TO: Design Review Commission
FROM: David Kornfield, Planning Services Manager
SUBJECT: 15-V-08 & 15-SC-24 – 55 Doud Drive

15-V-08 & 15-SC-24—55 Doud Drive

3. **15-V-08 and 15-SC-24 – T and E. Laliotis – 55 Doud Drive**

TO: Design Review Commission
FROM: David Kornfield, Planning Services Manager
SUBJECT: 15-V-08 & 15-SC-24 – 55 Doud Drive

SINGLE STORY SCHEME A
 FLOOR AREA : 3,500.00 SF
 LOT AREA : 10,134.00 SF

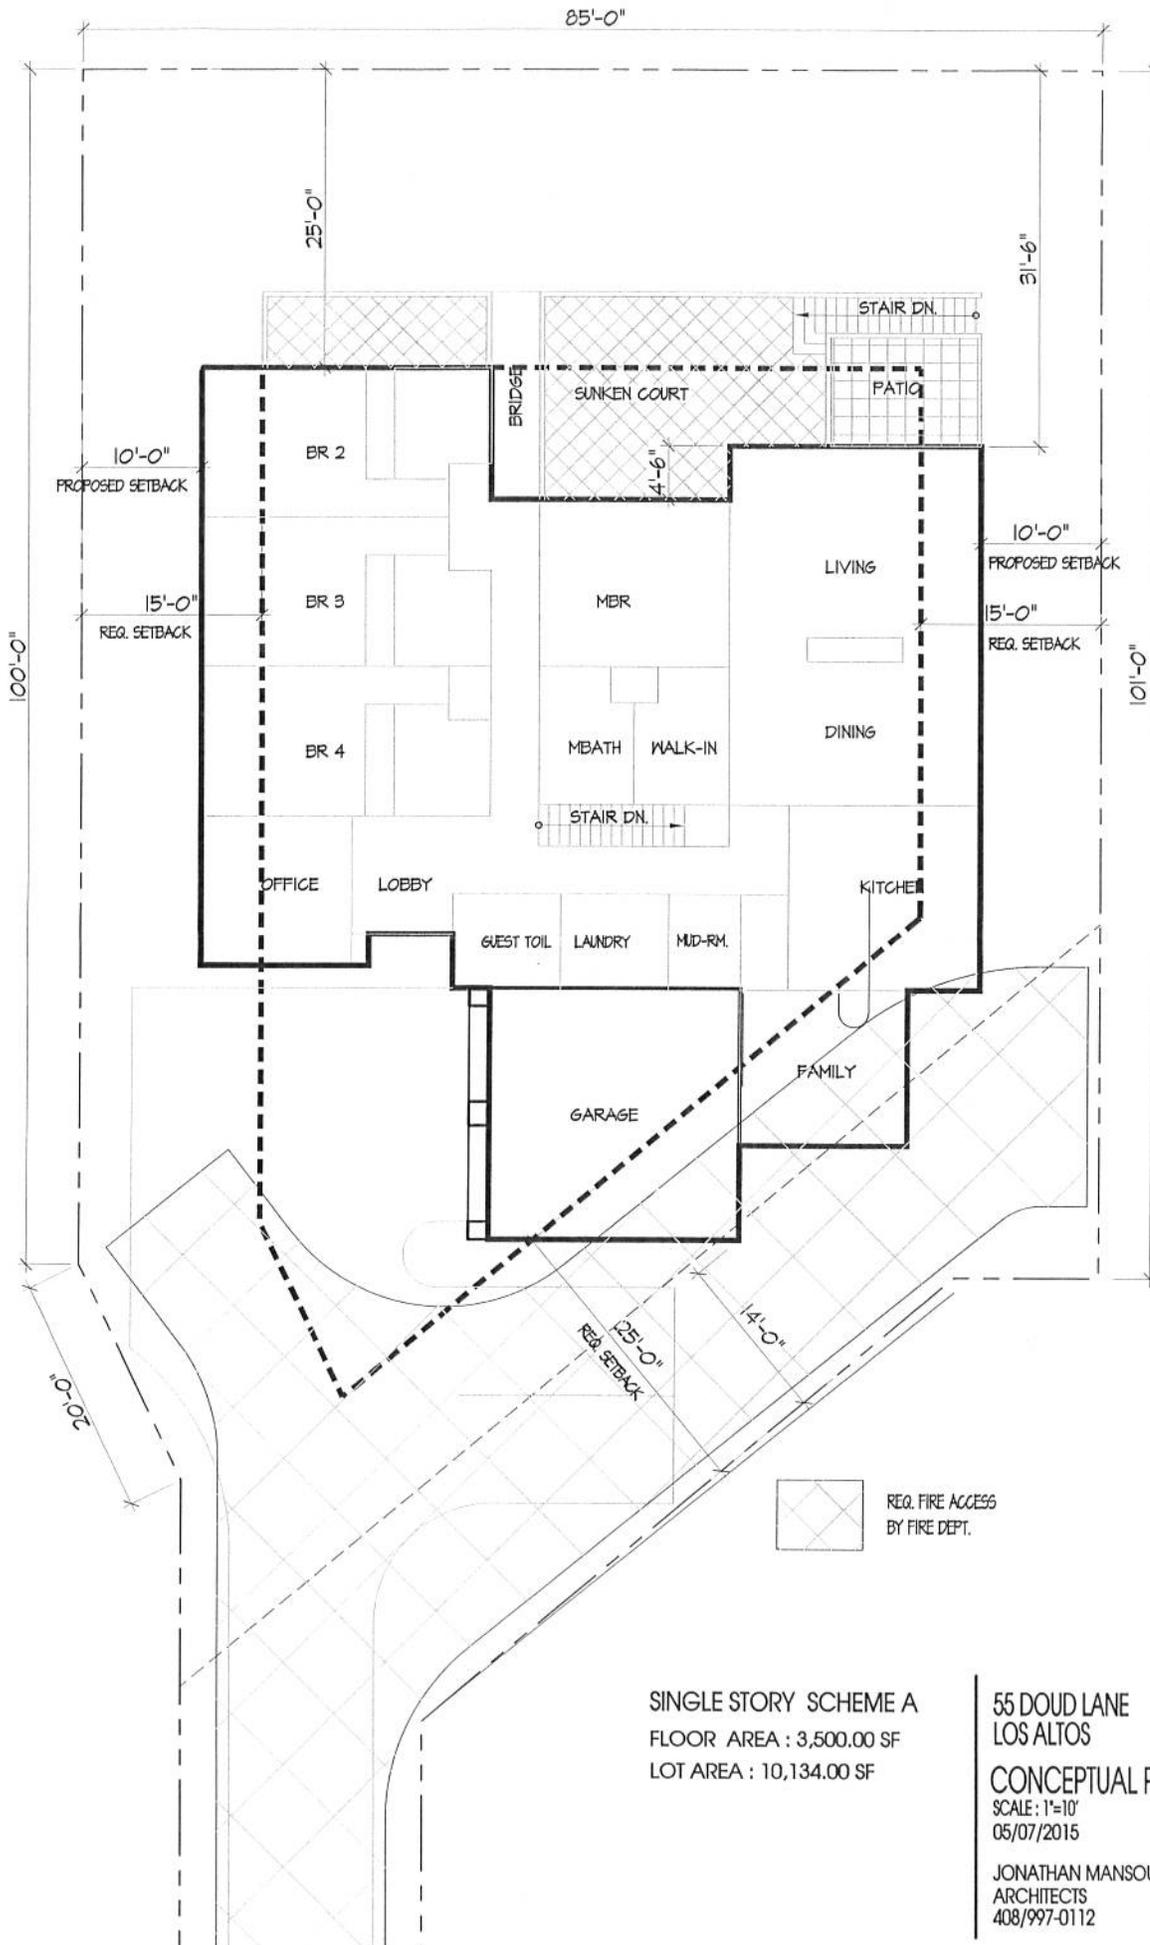
- Scheme A encroached into the required 15-foot side yard setback and the Fire Department turn-around area;
- Scheme B encroached into the required 15-foot side yard setback;

SINGLE STORY SCHEME C
 FLOOR AREA : 3,487.00 SF
 LOT AREA : 10,134.00 SF

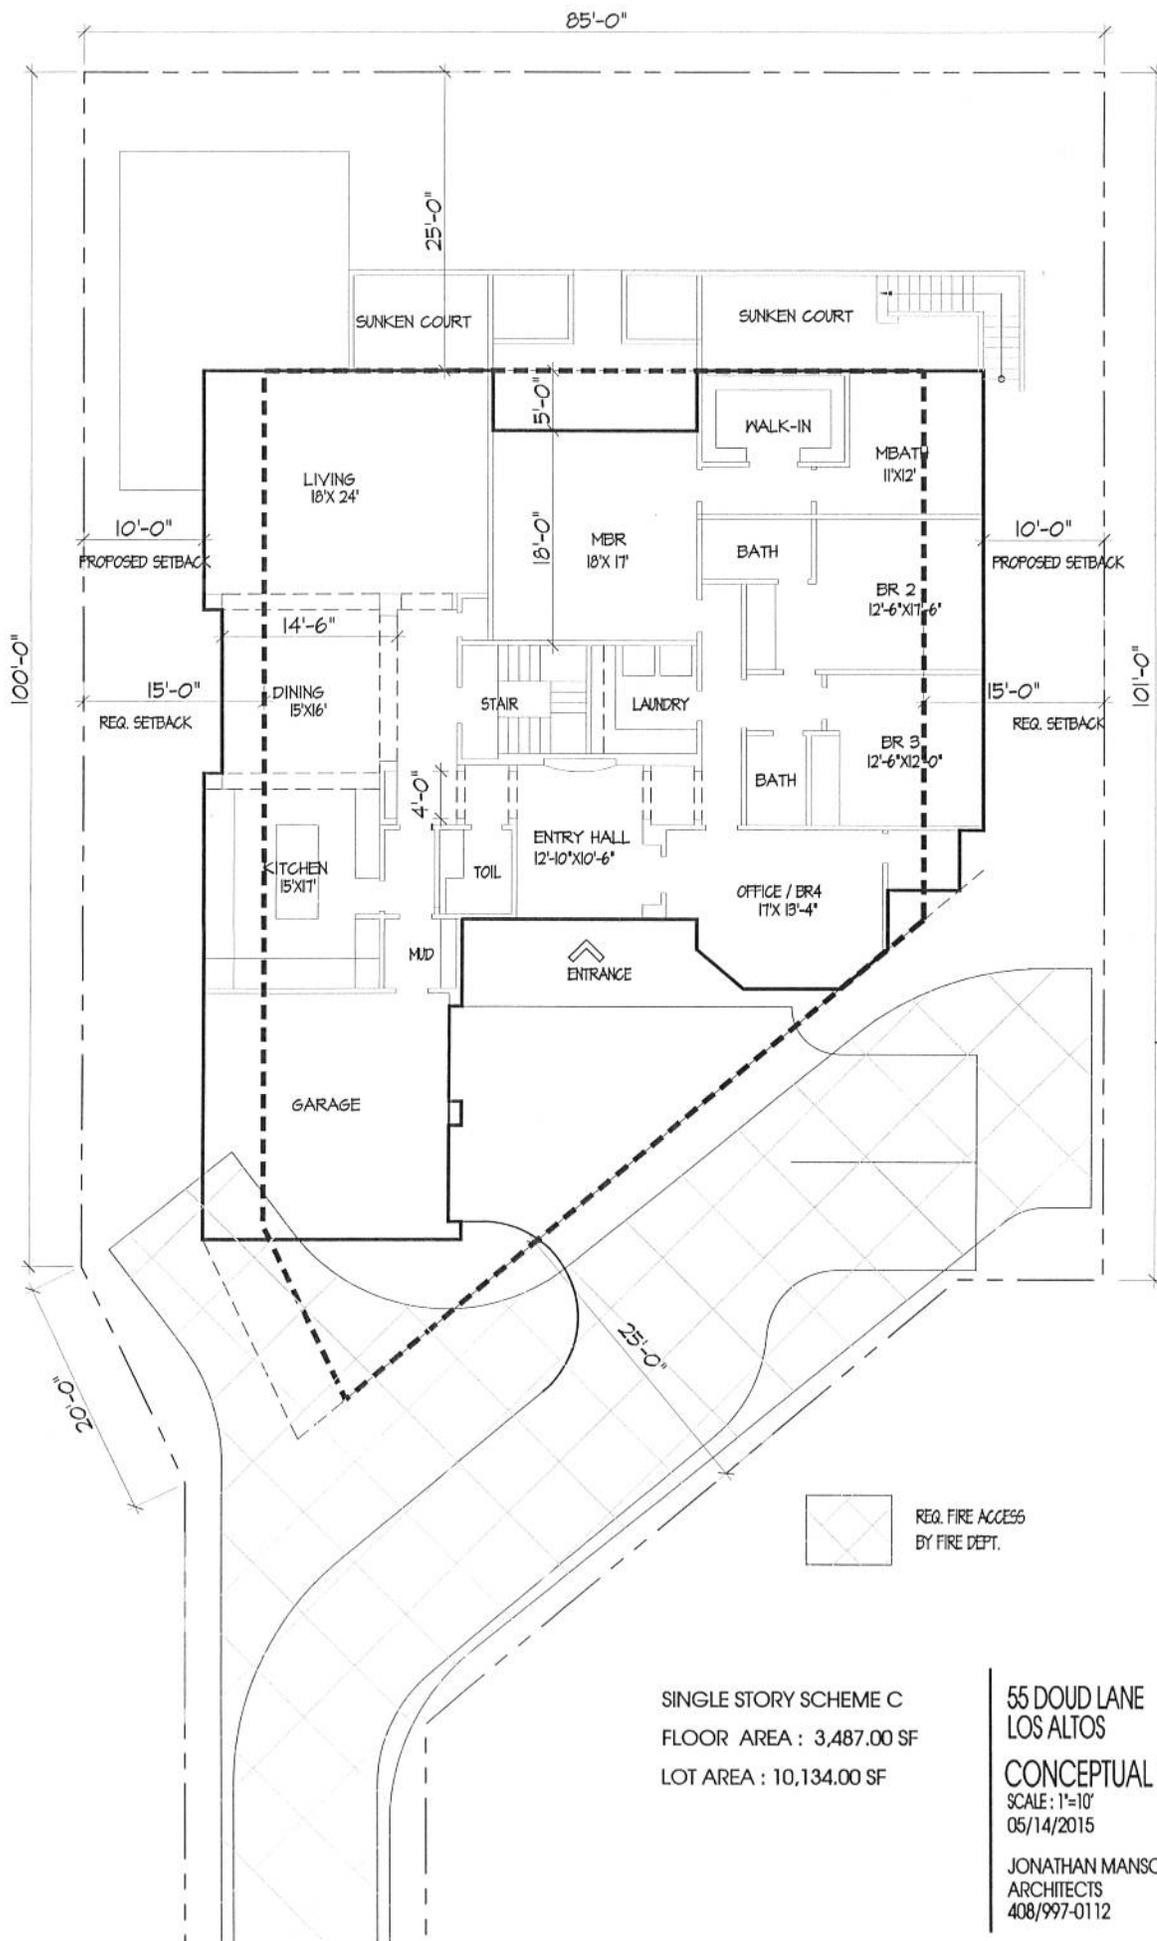
- Scheme C encroached into the required 15-foot side yard setback area and the Fire Department turn-around area; and
- Scheme D encroached into the required 15-foot side yard and the required 25-foot, rear yard, setback areas.
